SINGAPOREAN NOTICES TO MARINERS

NM 9/2020

| CORRECTION NO. | SNM EDN NO. | LAST CORR N O. | CHART NO. | Location on Chart | | |
|----------------|-------------|----------------|-----------|-------------------|--|---|
| 9 (Sheet 2) | 3 / 2020 | 6 / 2020 | 500 | | | X |

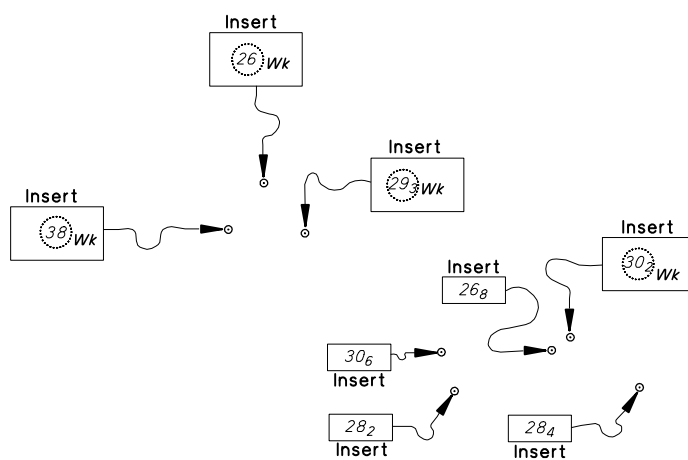
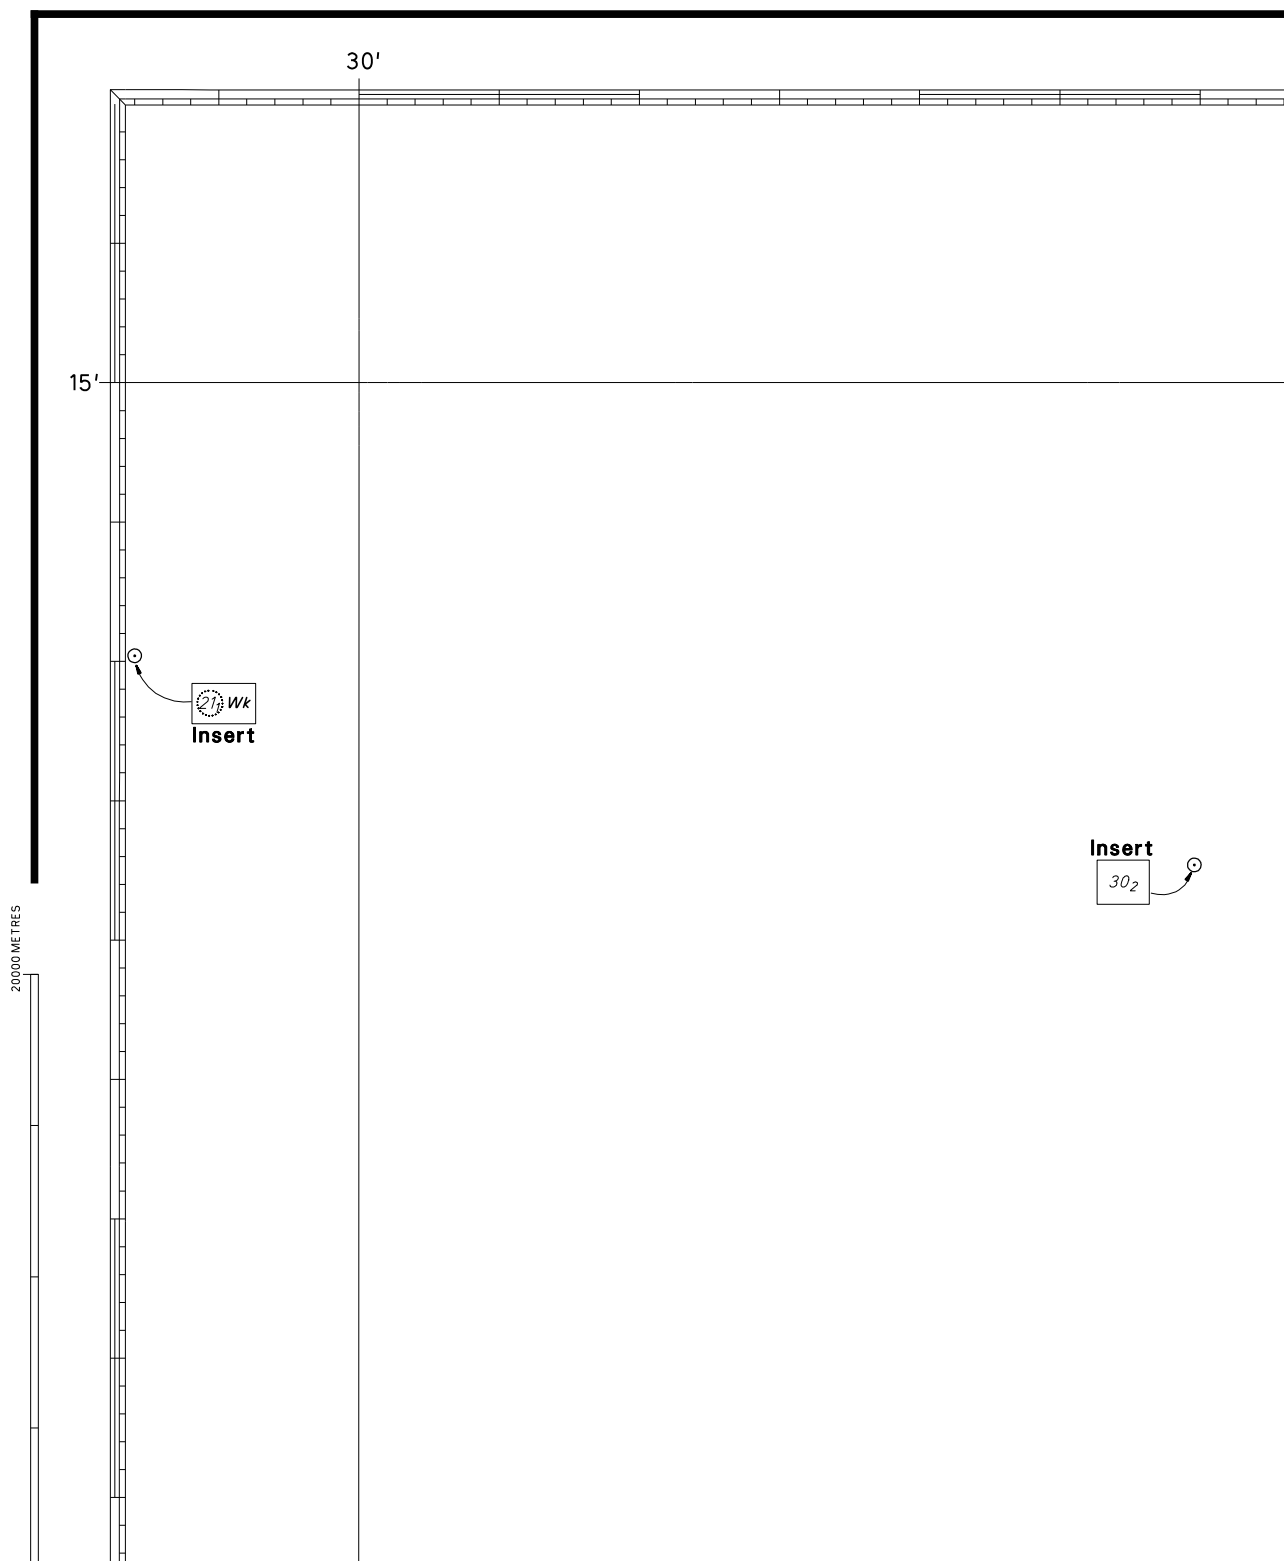
| 500 | 8 Ed 15/9/17 | Last NM 6/2020 | (Joint Hydrographic Survey of the Straits of Malacca and Singapore) NM 9/2020 |
| Delete |  <i>Wk</i> | 1°11.48'N | 103°37.22'E |
| Insert |  <i>Wk</i> | 1°15.06'N | 103°25.24'E |
| | depth, <i>27₆</i> | 1°15.72'N | 103°24.43'E |
| | depth, <i>29₂</i> , enclosed by 30m contour | 1°15.77'N | 103°24.10'E |

| Insert | the accompanying block, centred on : | | 1°15·04'N | 103°37·98'E |

| CORRECTION NO. | SNM EDN NO. | LAST CORR N NO. | CHART NO. | Location on Chart | | |
|----------------|-------------|-----------------|-----------|-------------------|---|--|
| 9 (Sheet 2) | 3/2020 | 6/2020 | 501 | | | |

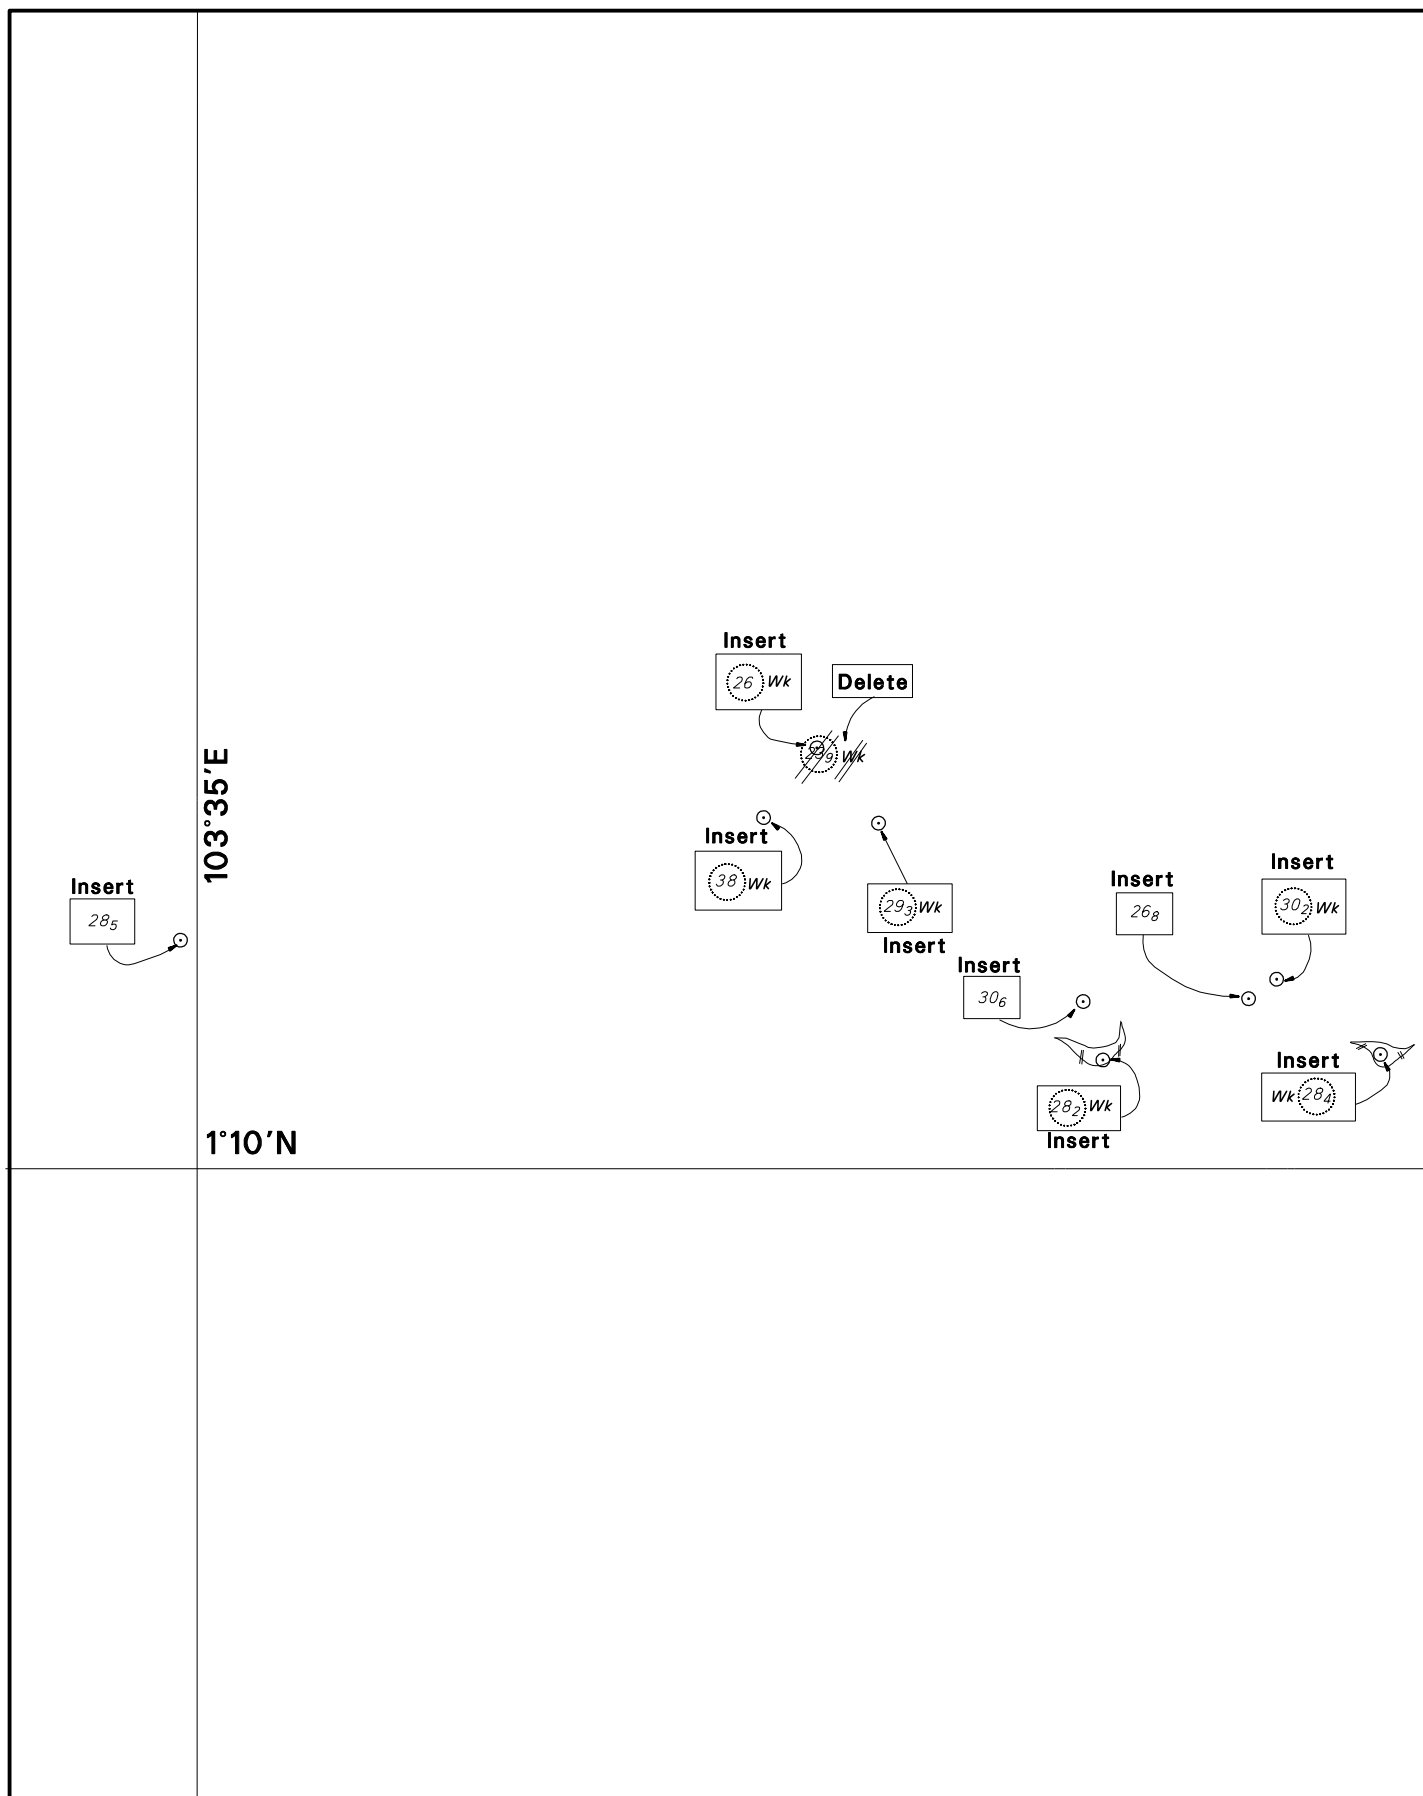
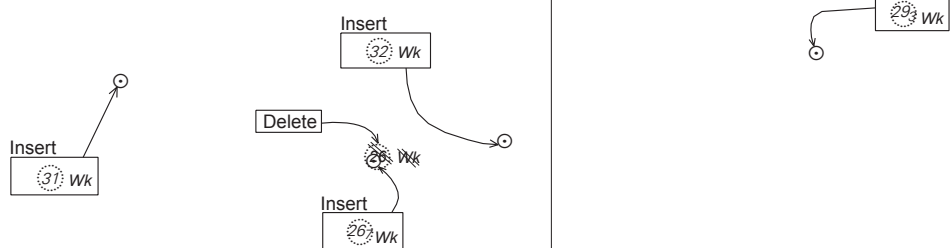
| 501 | 7 Ed 1/9/15 | Last NM 6/2020 | (Joint Hydrographic Survey of the Straits of Malacca and Singapore) | NM 9/2020 |
| Delete |  Wk | | 1°11·48'N | 103°37·22'E |
| Insert |  Wk | | 1°14·02'N | 103°29·20'E |
| | depth, 28_2 , and extend 30m contour N to enclose | | 1°10·39'N | 103°38·23'E |
| | depth, 28_4 , and extend 30m contour N to enclose | | 1°10·41'N | 103°39·22'E |
| Insert | the accompanying block, centred on : | | 1°15·04'N | 103°37·98'E |

| CORRECTION NO. | SNM EDN NO. | LAST CORR N NO. | CHART NO. | Location on Chart | | |
|----------------|-------------|-----------------|-----------|-------------------|--|---|
| 9(Sheet 1) | 3/2020 | 104/2019 | 502 | | | X |

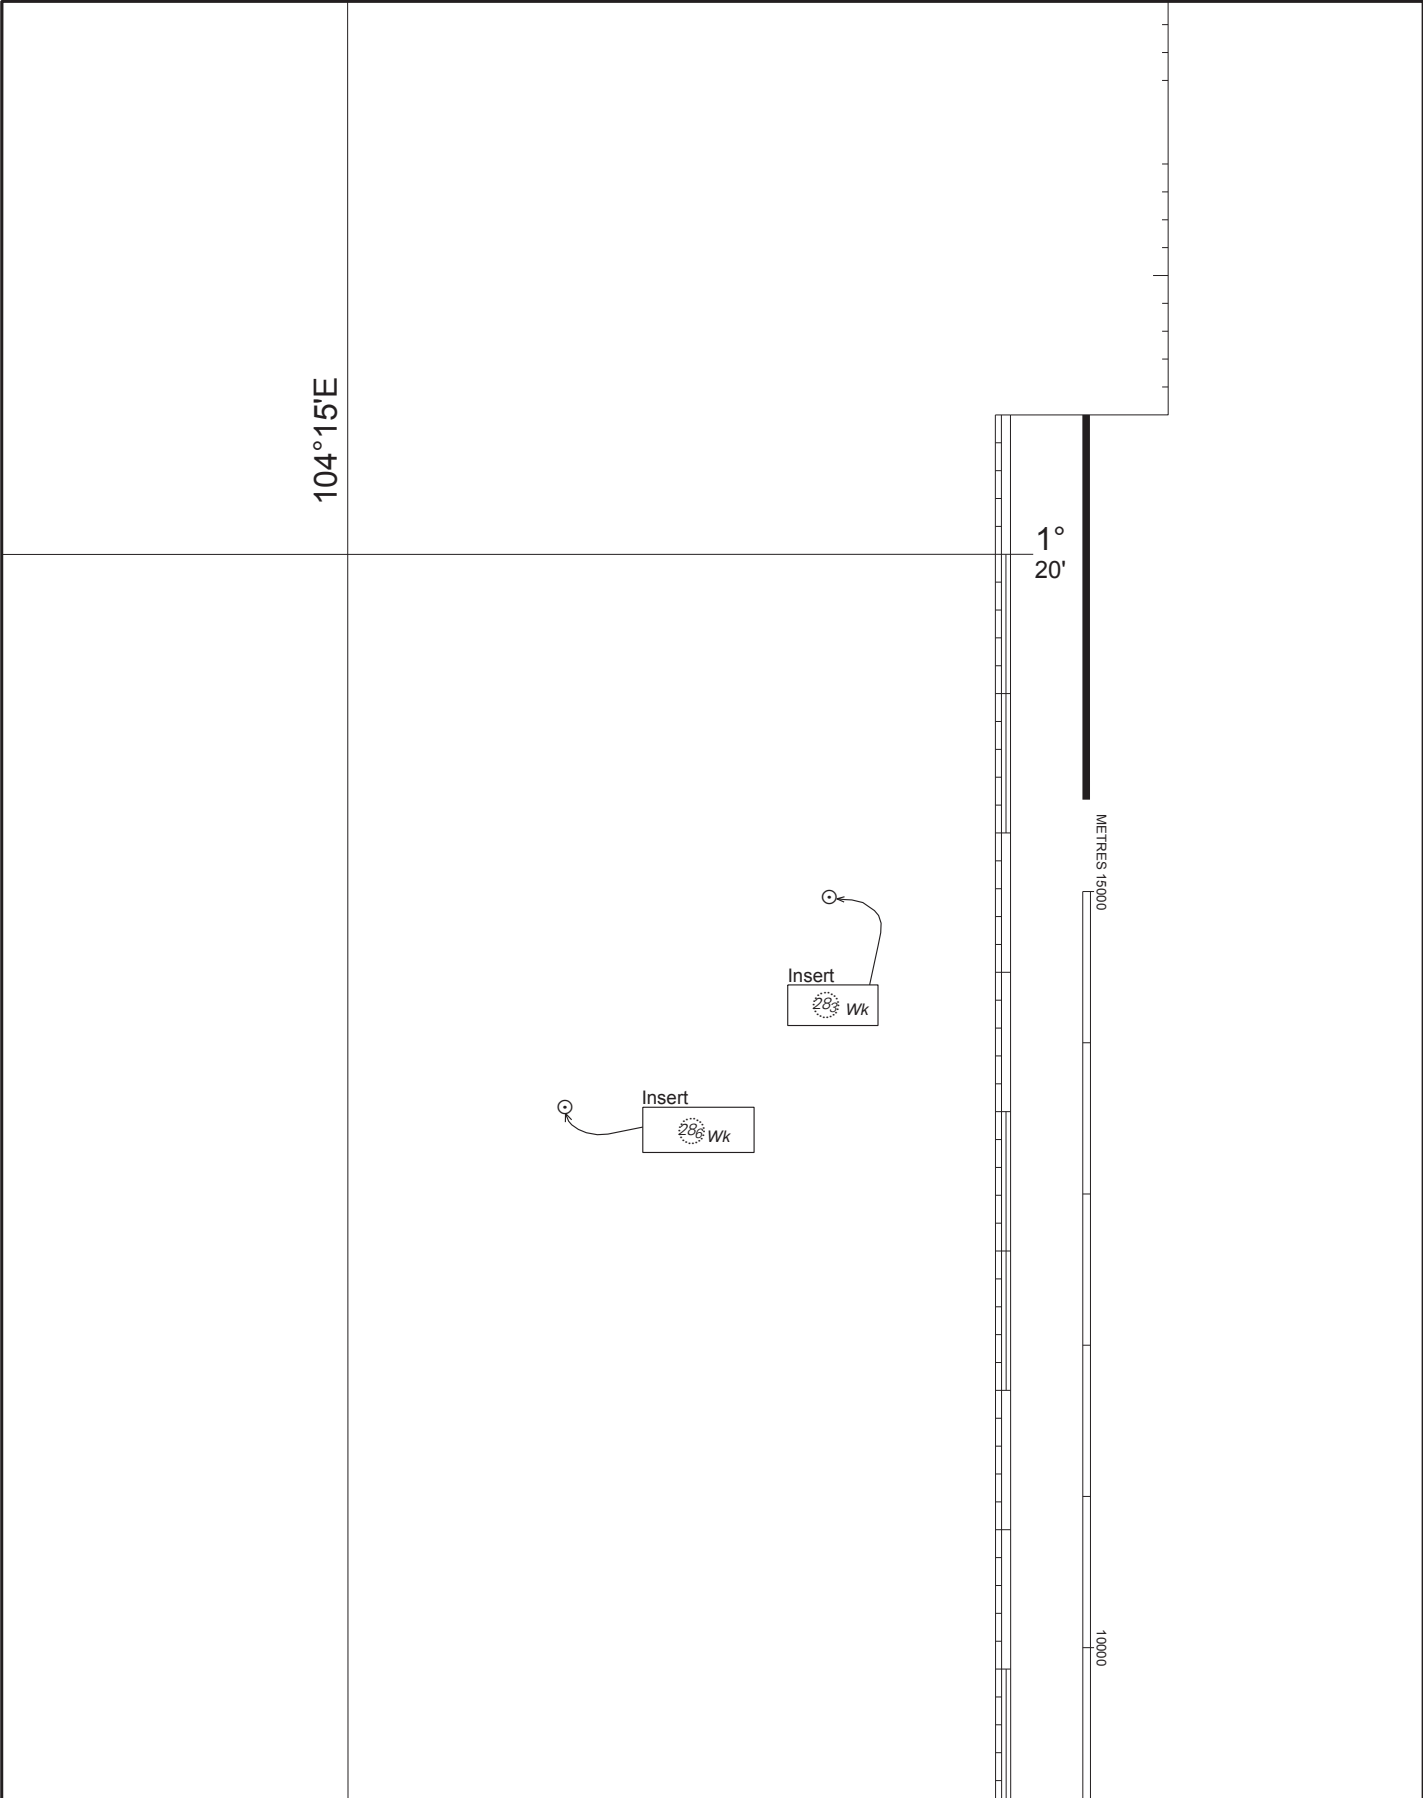
| 502 | 8 Ed 12/9/19 | Last NM 104/2019 | (Joint Hydrographic Survey of the Straits of Malacca and Singapore) | NM 9/2020 |
| Delete |  Wk | | 1°17·35'N | 104°09·38'E |
| Insert |  Wk | | 1°17·62'N | 104°08·47'E |

| Insert |  <i>Wk</i> | | 1°18·02'N | 104°15·77'E |
| |  <i>Wk</i> | | 1°18·77'N | 104°16·72'E |

| CORRECTION NO. | SNM EDN NO. | LAST CORR N NO. | CHART NO. | Location on Chart | | |
|----------------|-------------|-----------------|-----------|-------------------|--|--|
| 9 | 3/2020 | 113/2019 | 503 | X | | |

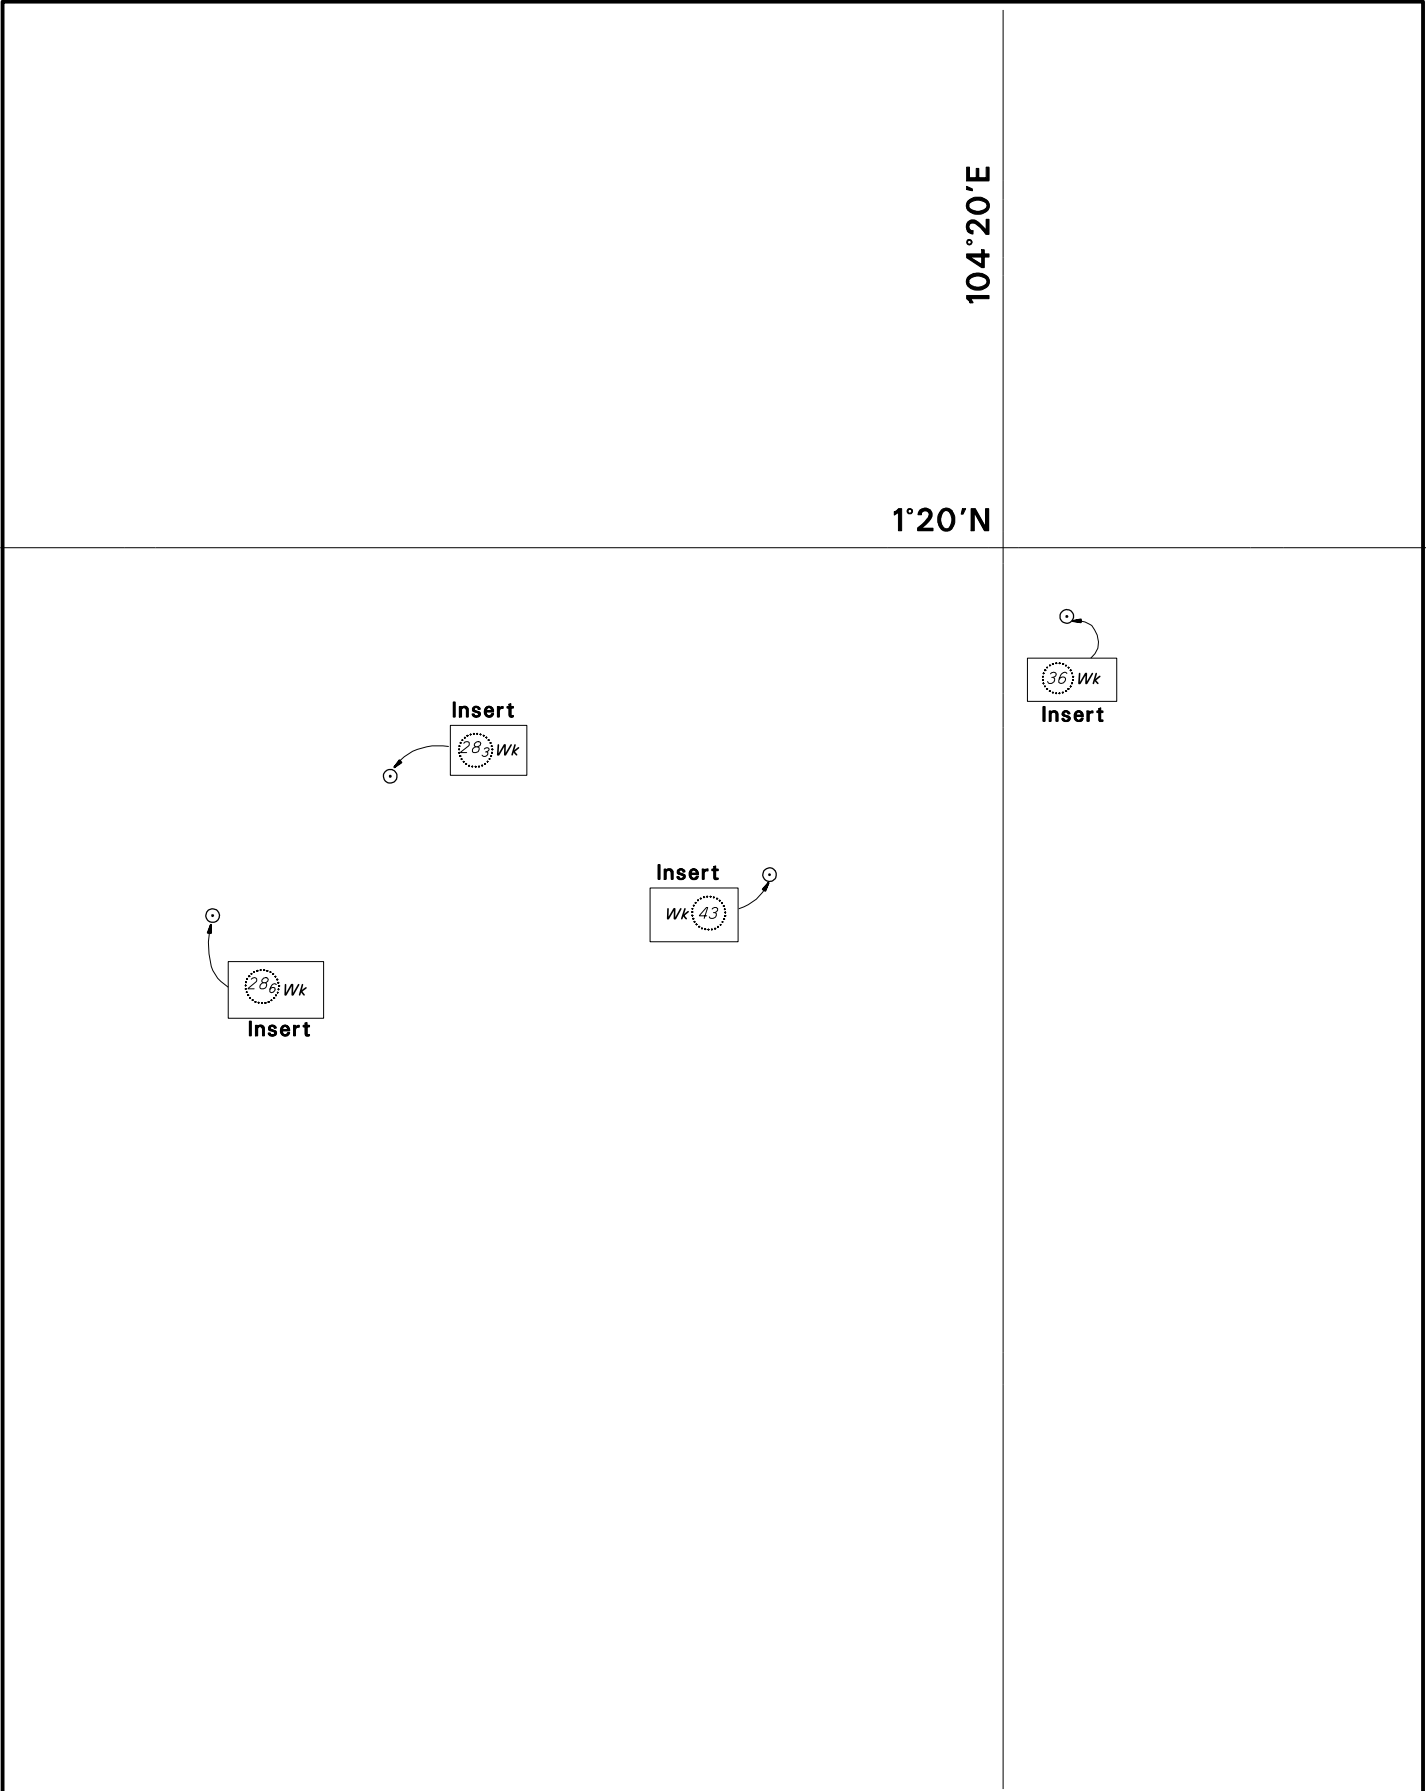
| 503 | 5 Ed 15/8/14 | Last NM 113/2019 | (Joint Hydrographic Survey of the Straits of Malacca and Singapore) | NM 9/2020 |
| Insert |  <i>Wk</i> | | 1°18·02'N | 104°15·77'E |
| |  <i>Wk</i> | | 1°18·77'N | 104°16·72'E |
| |  <i>Wk</i> | | 1°18·24'N | 104°18·75'E |
| |  <i>Wk</i> | | 1°19·63'N | 104°20·34'E |
